COLUMBIA BOROUGH PLANNING COMMISSION

Paul W. Myers Council Chamber, 308 Locust Street, Columbia December 20, 2022 – 7:00 p.m. Final Agenda

FINAL SUBDIVISION / LAND DEVELOPMENT PLAN LANCASTER LEBANON HABITAT FOR HUMANITY

Advisory Plan Review Comments

COVER SHEET

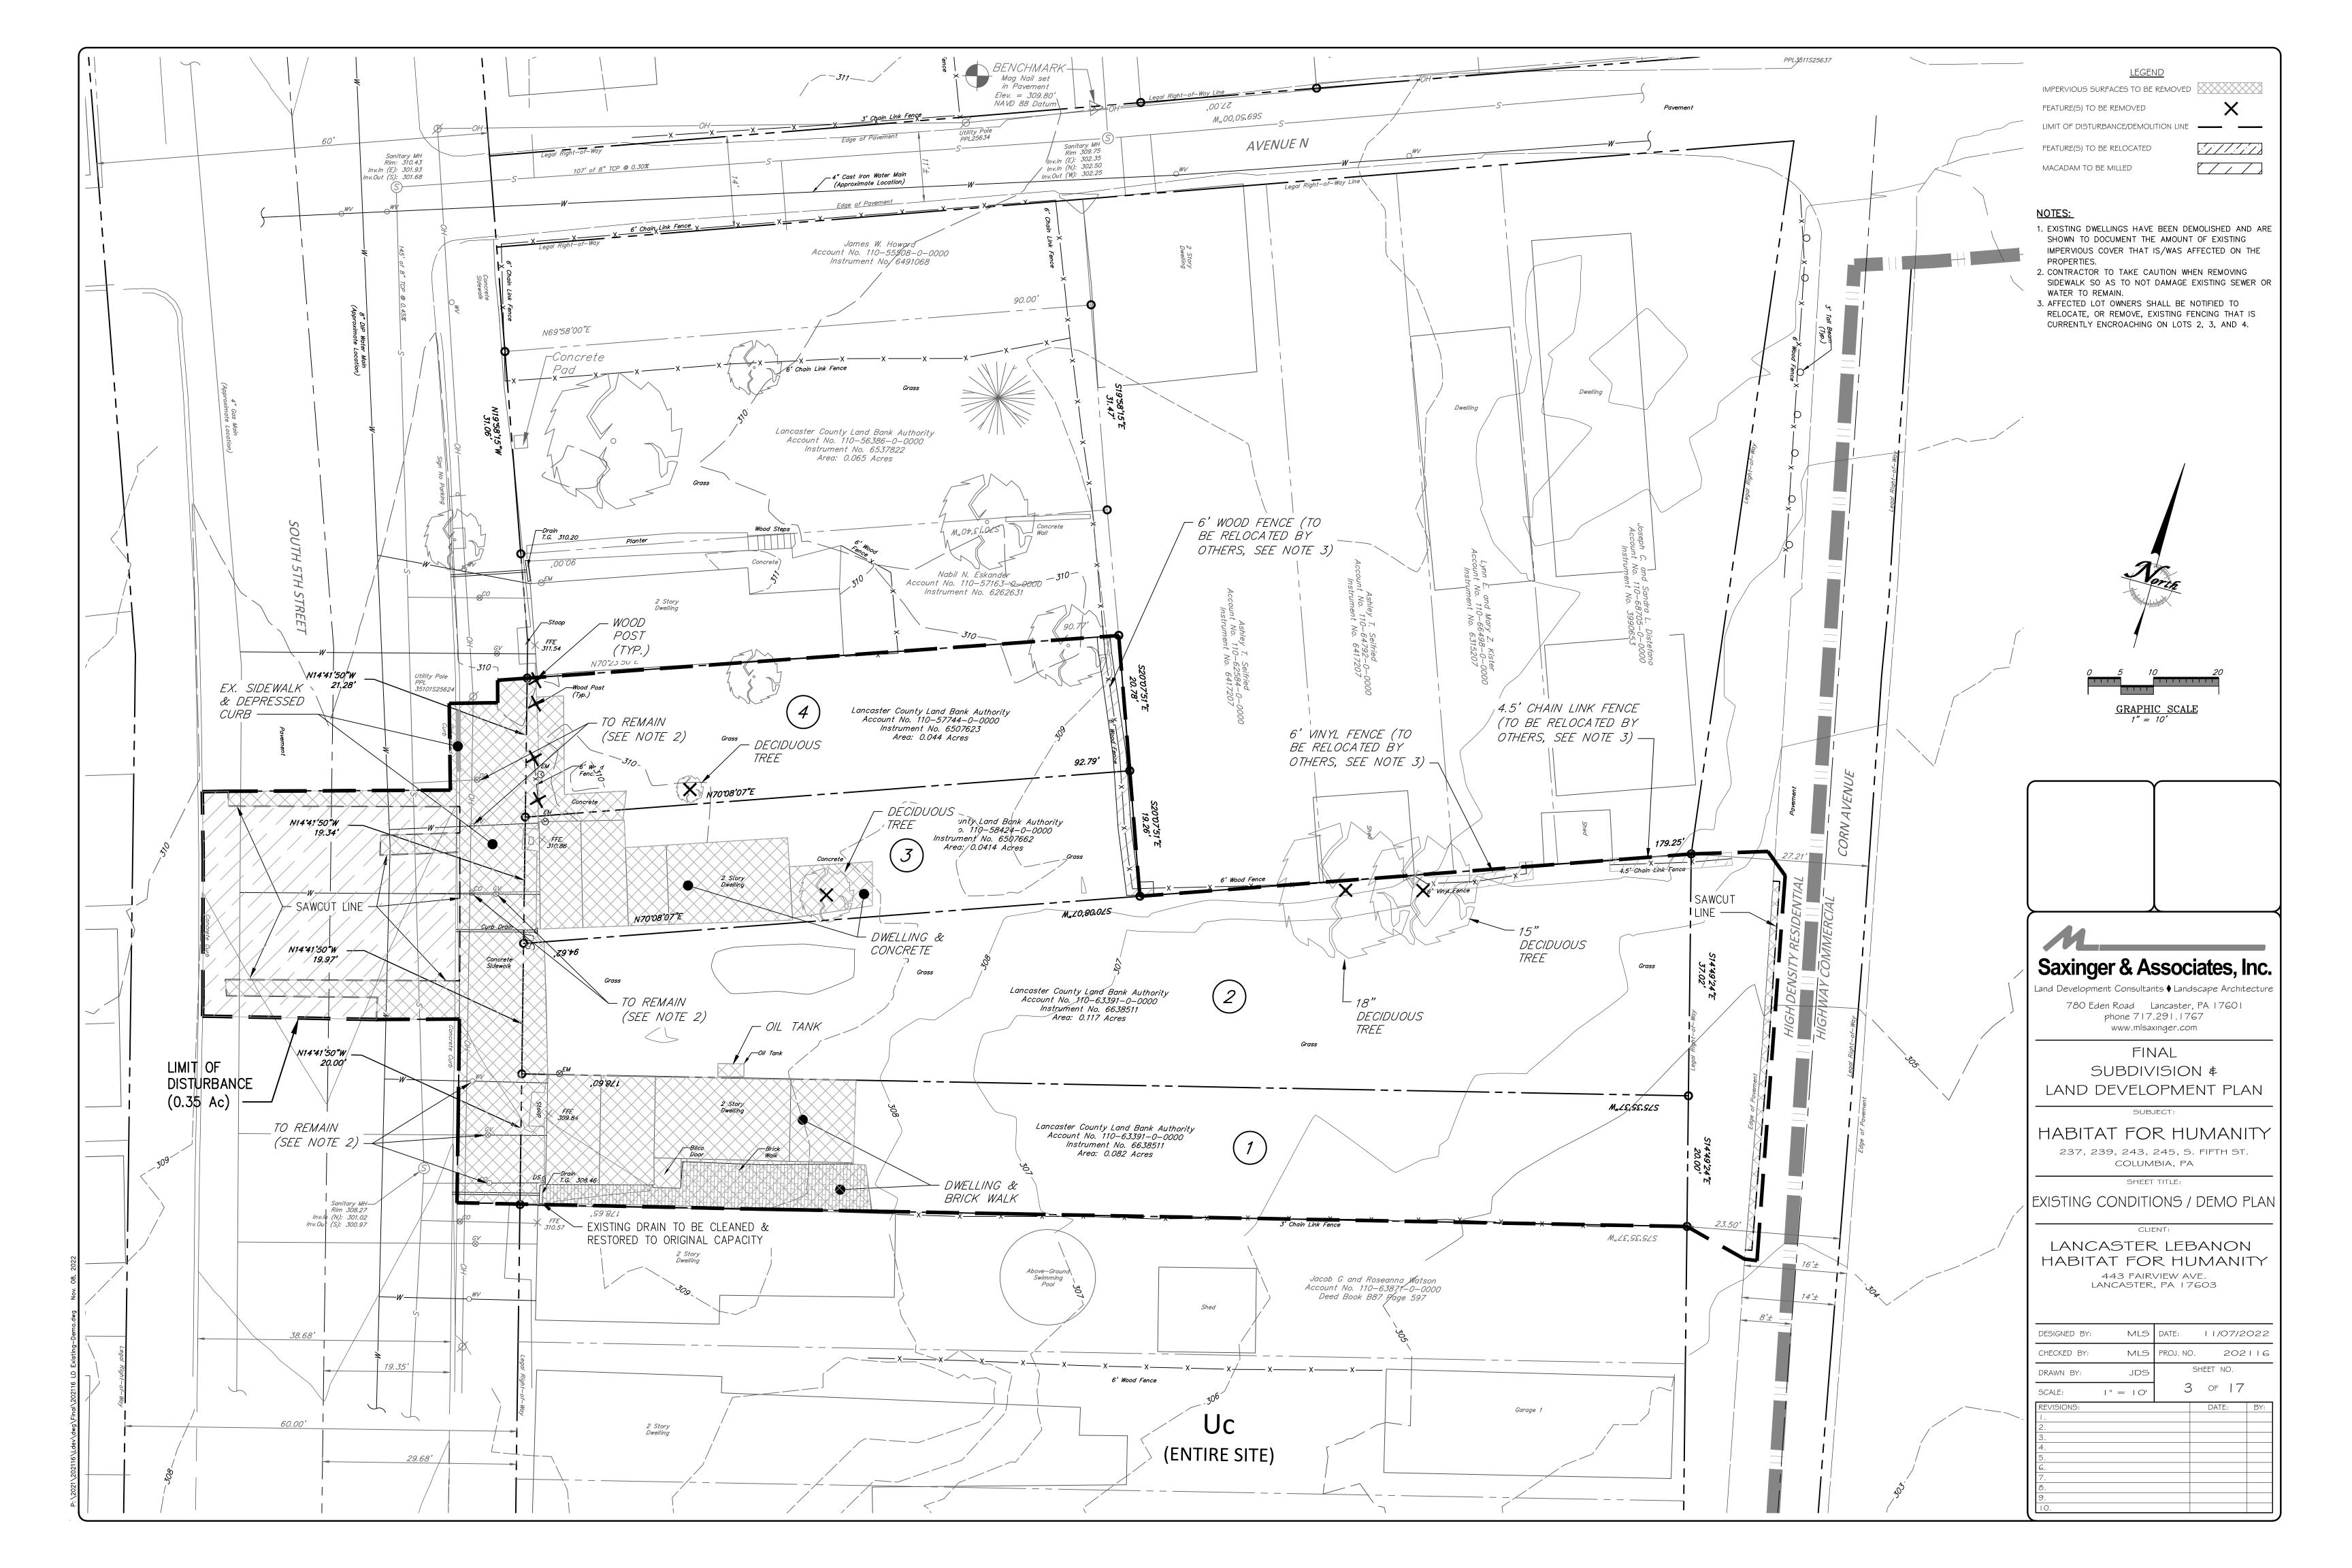
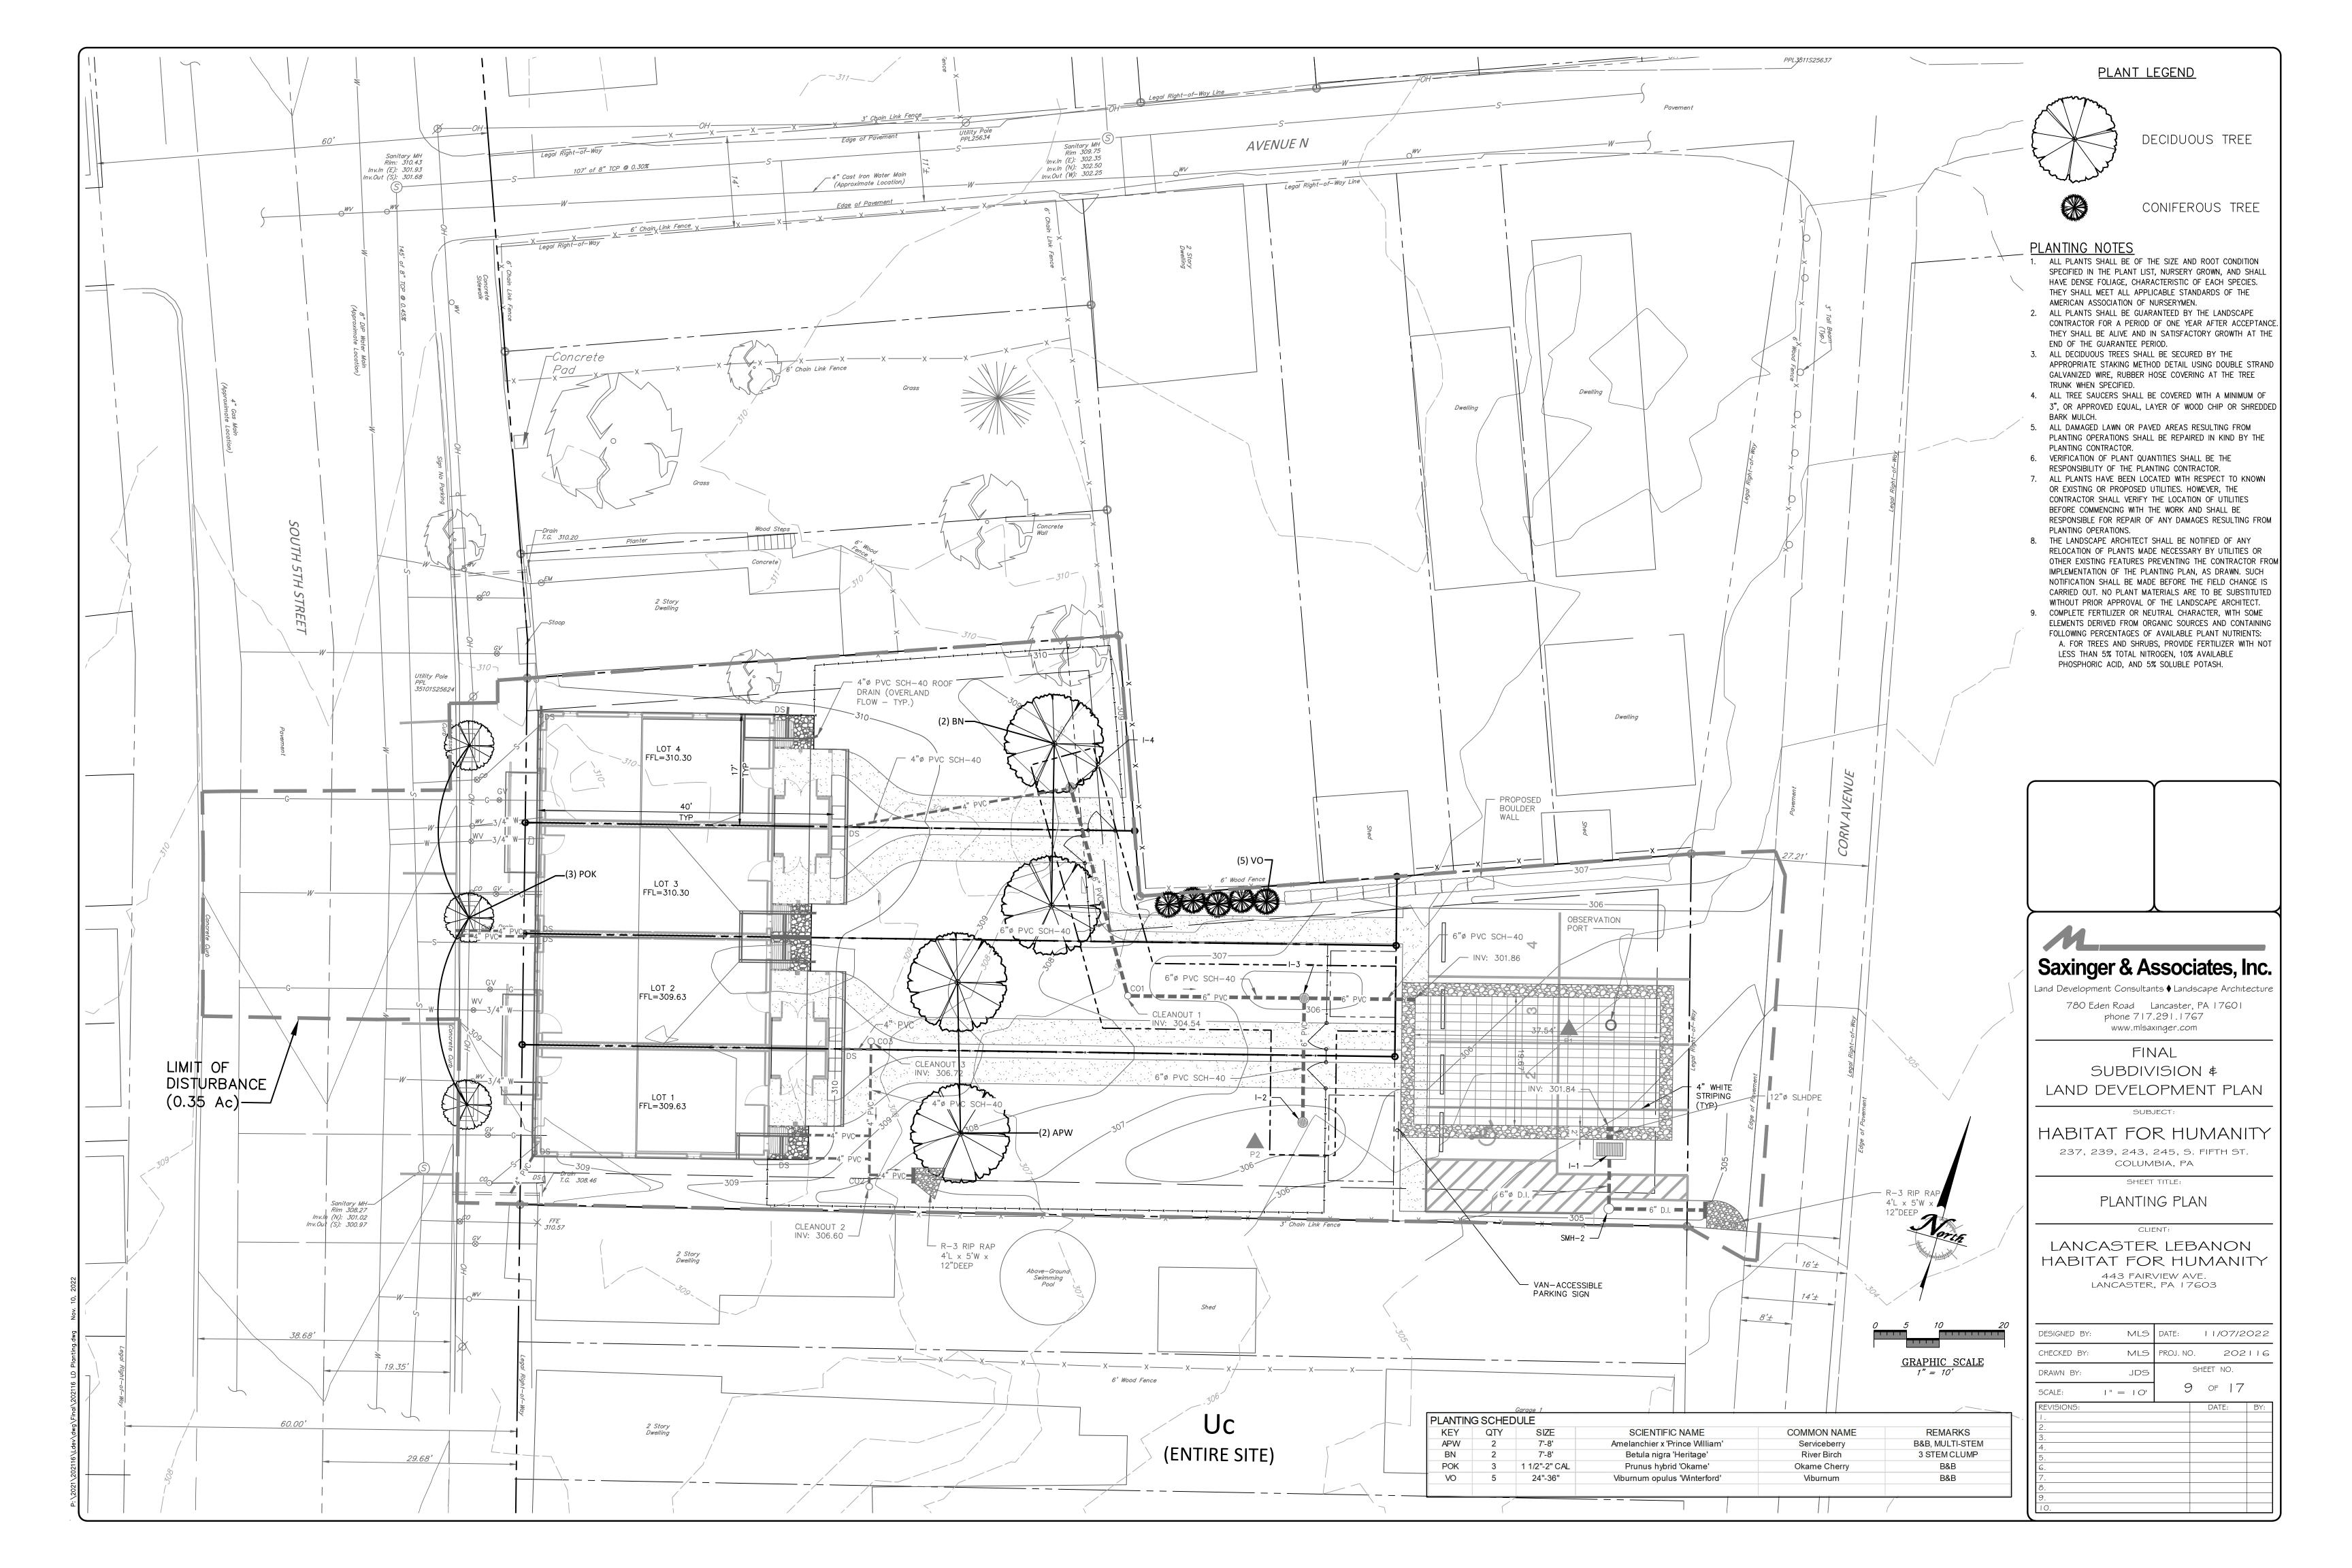
- County records identify the Tax Account # of Lot 2 as 1106361600000, not 1106339100000. Owner information on Sheet 1 of 17 should be confirmed and corrected on the plans to be recorded.
- 2. Revised deeds for the resultant lots should be recorded as part of this plan approval.
